# service bulletin

No. 98-11

# Required MIE 7.4L MPI (L29) ECM Replacement

1998 MIE 7.4L MPI (L29) Inboard Engines: S/N 0L002006–0L007302

72801

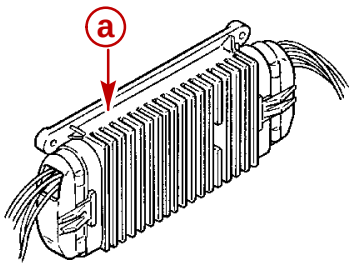
Under certain operating conditions, the engine may stall when shifted into reverse gear.

An ECM with a check sum number of A194 is good and it does not need to be replaced. If the ECM has any other check sum number, it must be replaced.

**a -** Check Sum Number On White Tag - A194 Is The Correct ECM.

861736T 1 ECM (A194)
